## Executive Director's Recommendation

Commission Meeting: December 3, 2015

**National China Garden**

Approval of comments on concept design

WHITE PAGODA ELEVATION

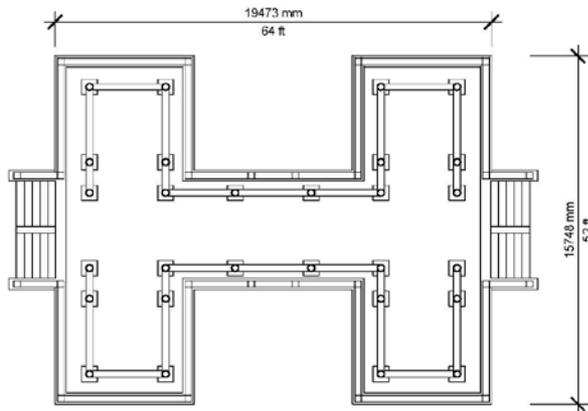
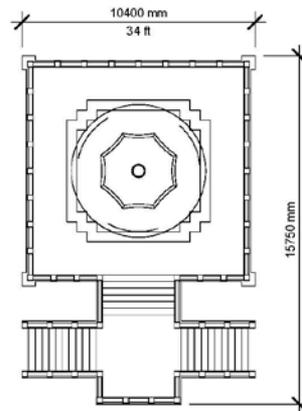
- Provide a vegetated buffer to screen the maintenance building along Holly Spring Road.
- Pending the visual study of viewsheds noted above, examine alternative locations for the White Pagoda.
- Consolidate parking as feasible to provide a more efficient layout and limit ground disturbance.
- Ensure that the proposed structures, including service buildings, have a compatible architectural vocabulary consistent with the garden complex.

- Provide a vegetated buffer to screen the maintenance building along Holly Spring Road.
- Pending the visual study of viewsheds noted above, examine alternative locations for the White Pagoda.
- Consolidate parking as feasible to provide a more efficient layout and limit ground disturbance.
- Ensure that the proposed structures, including service buildings, have a compatible architectural vocabulary consistent with the garden complex.

# Landscape and Structure Lighting – Approach

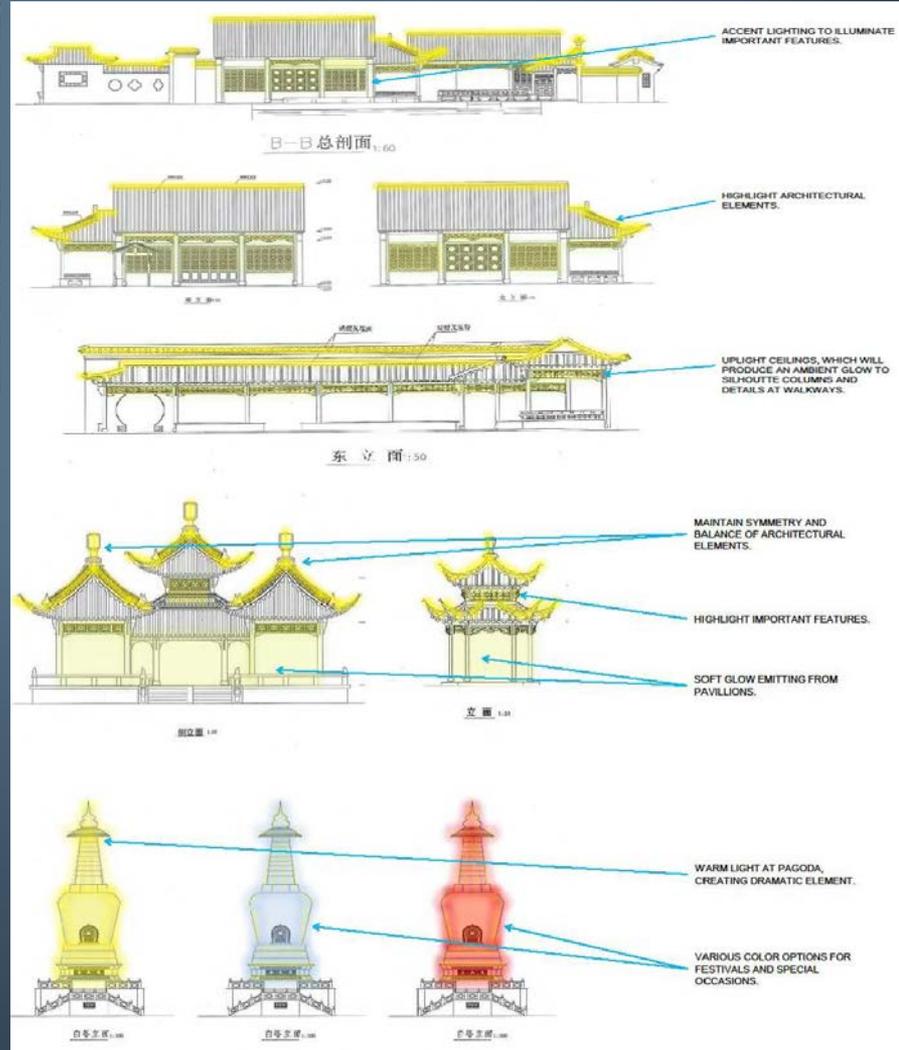
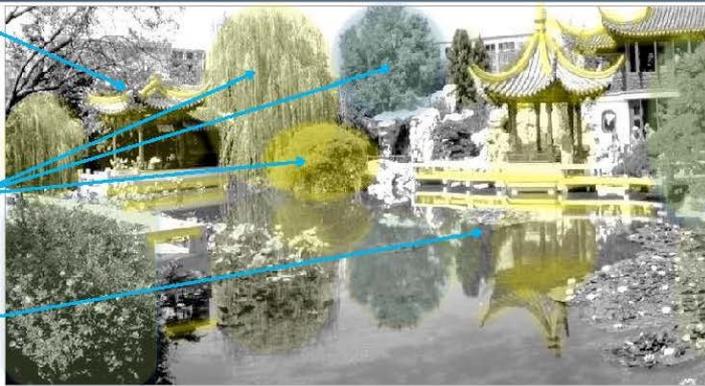
- Consider the placement, intensity, and programming of lighting as to not detract from the views to important symbols and civic buildings, particularly within the Arboretum setting.

The China Garden proposal includes a site and landscape lighting approach to allow visitors to safely navigate throughout the site, highlight significant architectural and landscape details, and provide an engaging and visually dynamic experience. According to the applicant, this will be achieved by carefully selecting lighting fixtures, locating them at pathways, bridges, landscaping, parking areas, and the exterior of structures. Given the height of the proposed structures, the topography, the proximity to residential neighborhoods and potential views to Washington, DC, staff recommends to study lighting impacts further.
